Development Facilitation Team (DFT) – Review Comments

Project No: PR-2024-010069 Date: 06/26/2024 Agenda Item: #4 Zone Atlas Page: G-12

Request: VACATION OF ADJOINING PORTION OF ACEQUIA (579 SQ FT), GRANT OVERHEAD PUBLIC UTILITY EASEMENT, PLAT TO CREATE ONE NEW LOT FROM ONE EXISTING LOT

Location: 2618 Veranda Rd NW between Trellis Dr NW and Glenwood Rd NW

FIGURE 7.2.41 Street Element Dimensions Along Major Roads

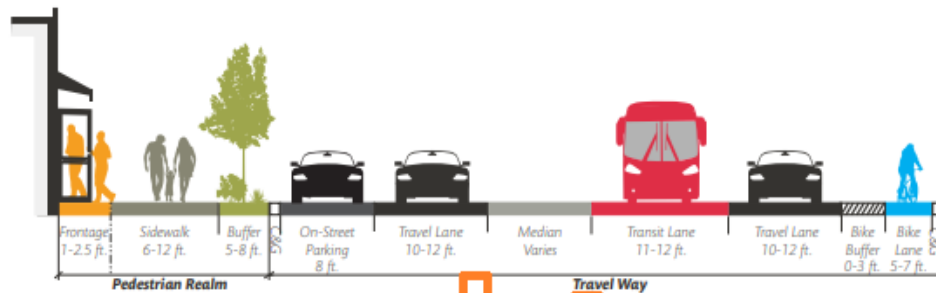
- Sidewalks meeting the standards of the DPM shall be provided along the entire frontage of each lot.

Confirm if the sidewalks are meeting the current requirement per 7.2.29 of the DPM as shown below.
